**Support Bulletin-SB-25-10043**  
**Date-3.25.2025**  
**Title: QuickDraw MY 25 Changes**  
**Product Line: Spray Tender**  
**Model: QuickDraw 3000**  
**Level: Public**  
**Author(s): Andy Boyle**  
**Revision Letter: A**

The following changes have been made on the MY25 QuickDraw Max Cabinets

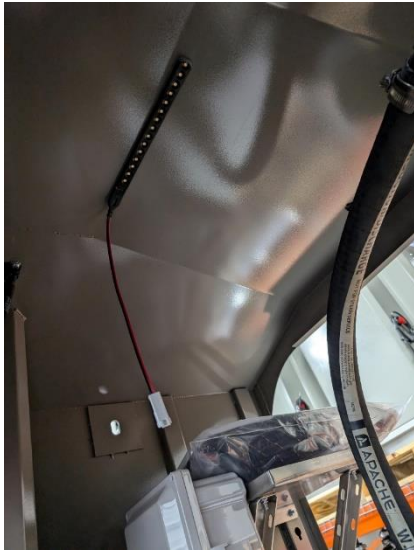
3. New controller Mounting bar / plate with Raven texture and single pim nut in on each side.
  - a. 475-2339Y1- BK QuickDraw Controller Mount Bar
  - b. 475-2338Y2-RV Quickdraw Controller Mount Plate
  - c.
